Cory Decarbonisation Project

Responses to Deadline 3 submissions on behalf of Landsul Limited and Munster Joinery (U.K.) Limited

Cory Decarbonisation

Electrical Assessment

Figure 2-1: Cory DCO 132/33 kV single line diagram.

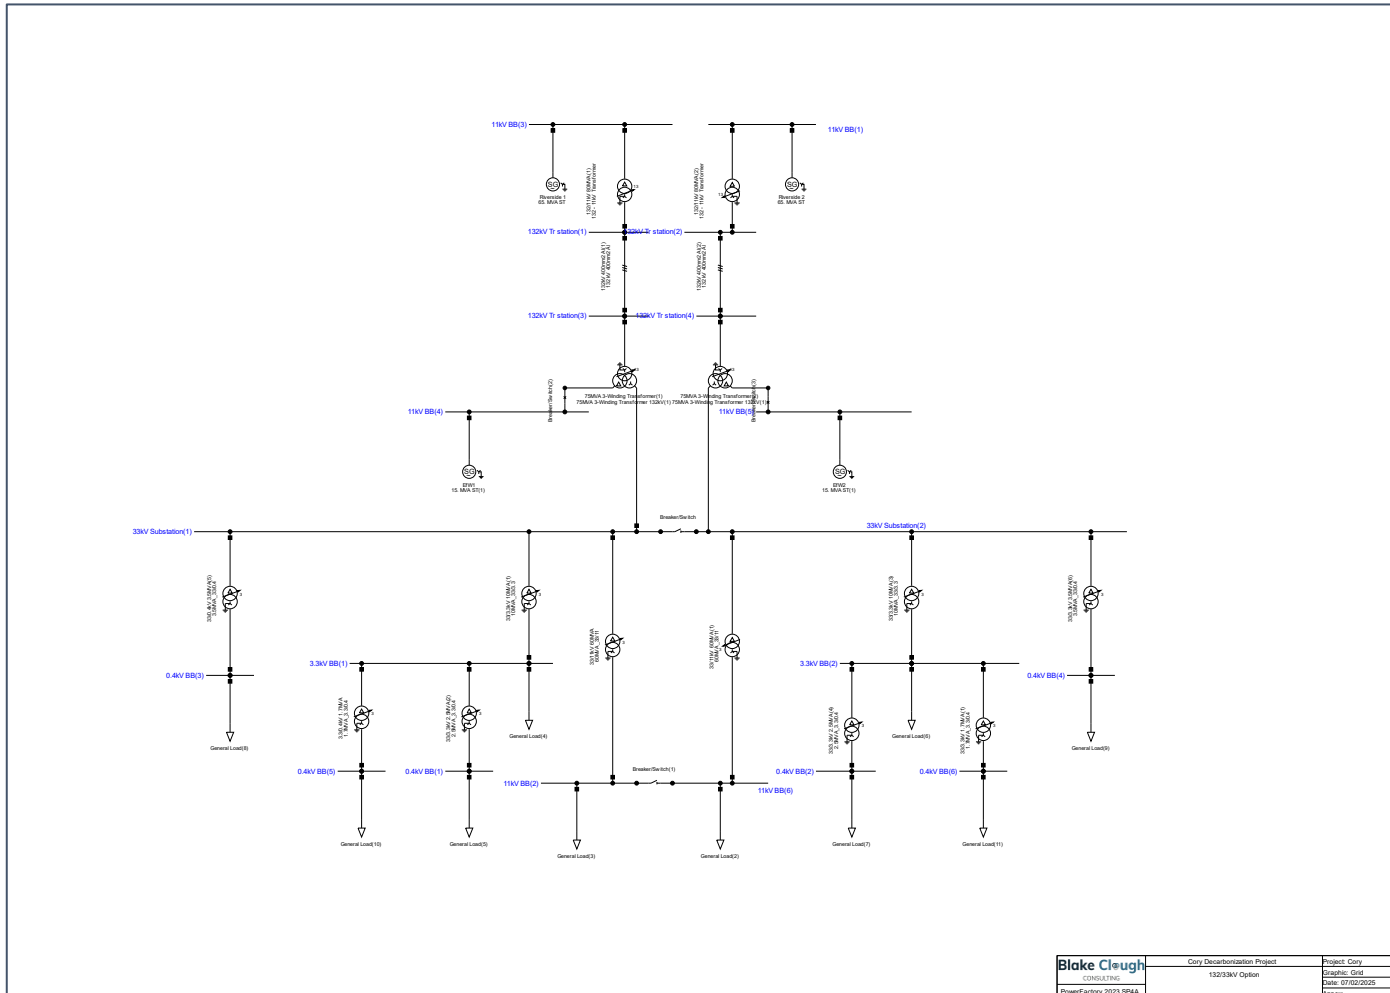
The total losses for the 132/33 kV option are around 5.174 MVA and the major contributors to these losses are the transformers, in particular the 75 MVA 3-winding combining transformers.

Figure 2-2: Cory DCO 11 kV single line diagram (alternative option)

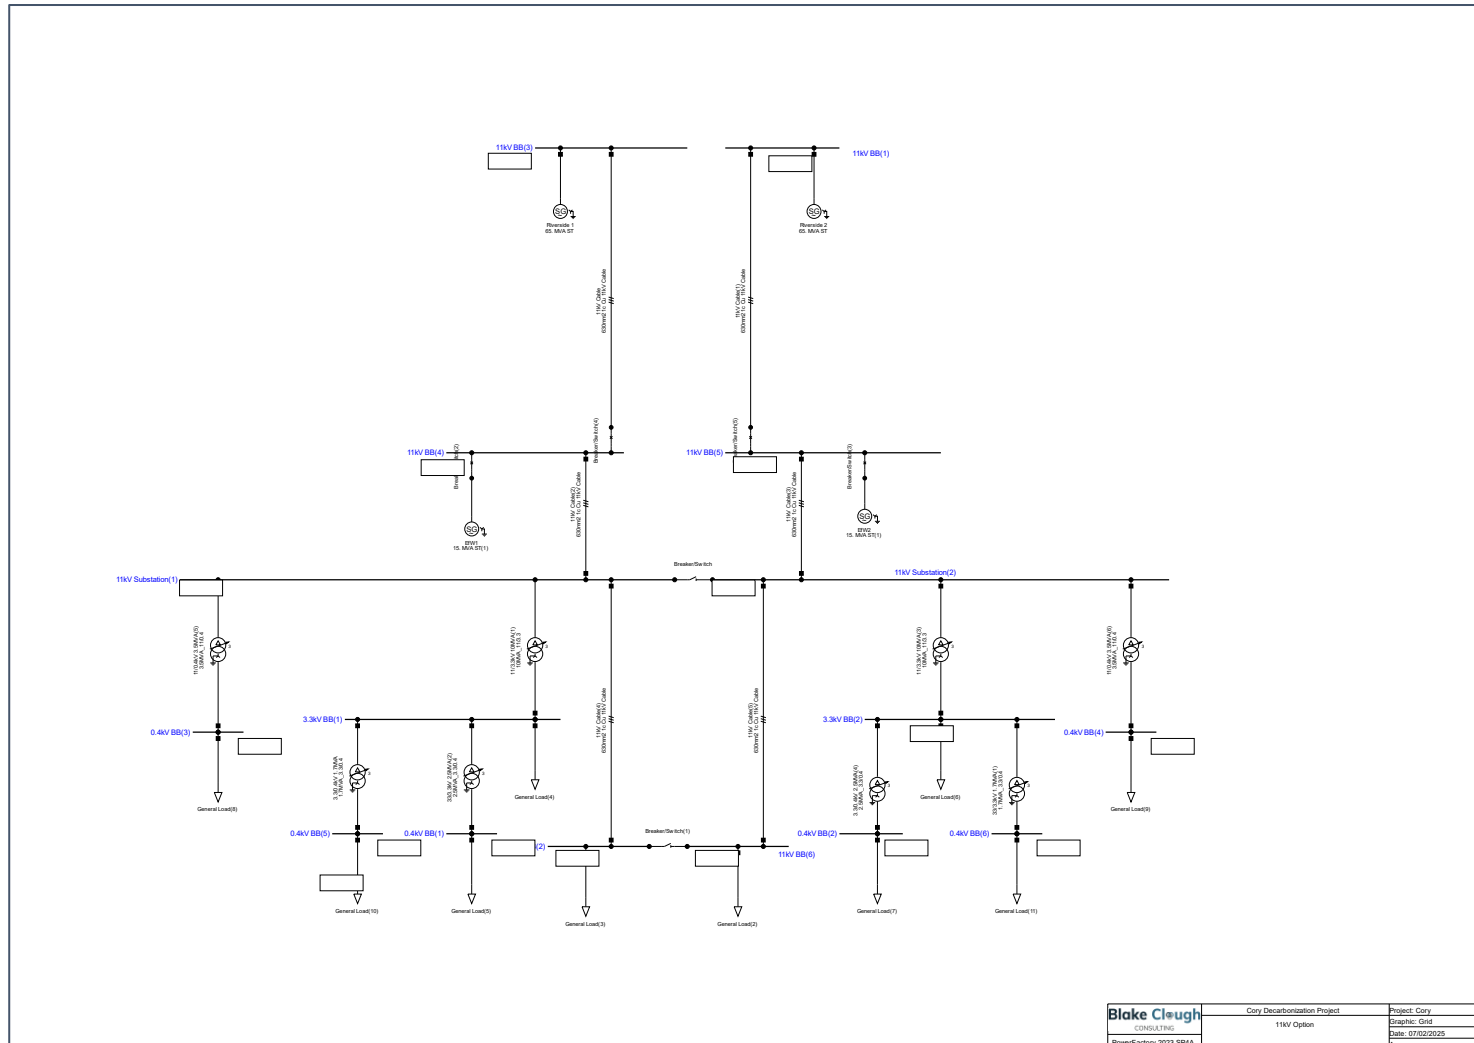
The total losses in this option are around 0.332 MVA as there are no major transformers in this option, the length of 11 kV cables is within 250 m which is not a significant length for 11 kV, and all small distribution transformers are not fully loaded.

The loss comparison between the two options reveals that the 11 kV configuration results in approximately 93.5% less loss compared with the 132/33 kV options. Although an 11 kV option would typically incur higher losses due to higher current, in this case the shorter cable length and the elimination of multiple transformers which were the primary sources of losses means that the 11 kV option significantly more efficient.

Figure 3-1: 11 kV Switchgear.

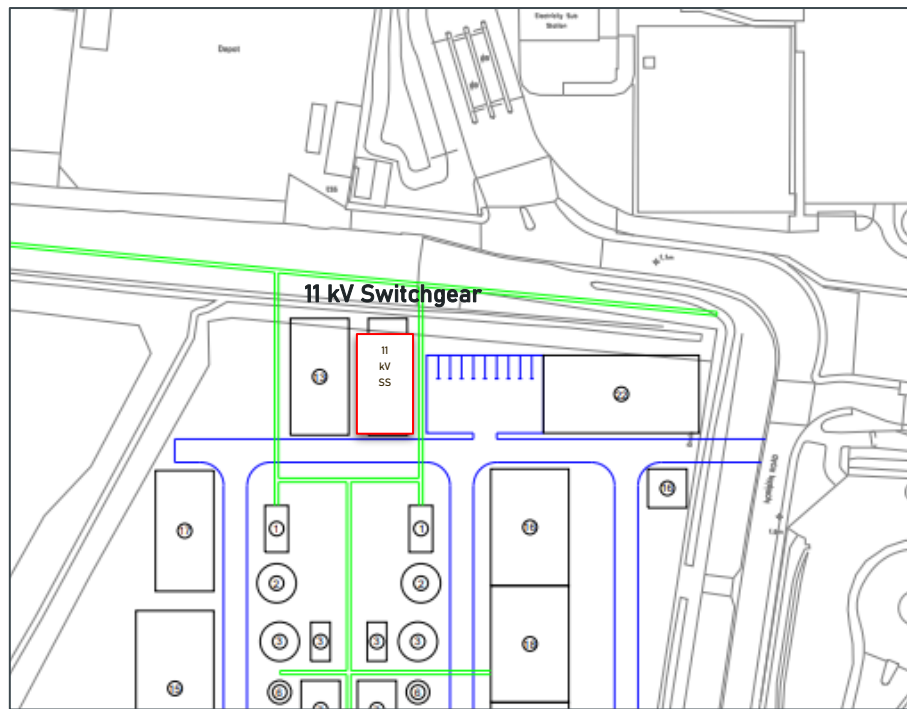
Since there is no 132/33 kV transition in the 11 kV option, the space requirement has been reduced significantly. The 11 kV cables connecting the Riverside 1, 2 and 2 x back-pressure steam turbines can be combined at 11 kV switchroom, and from this switchroom the power can be distributed to different loads. The size of this room is estimated to be around ~10 m x 7 m.

The proposed 11kV switchgear location would replace the Applicant's original proposal for the 132kV substation (item 10 on the Applicant's equipment).
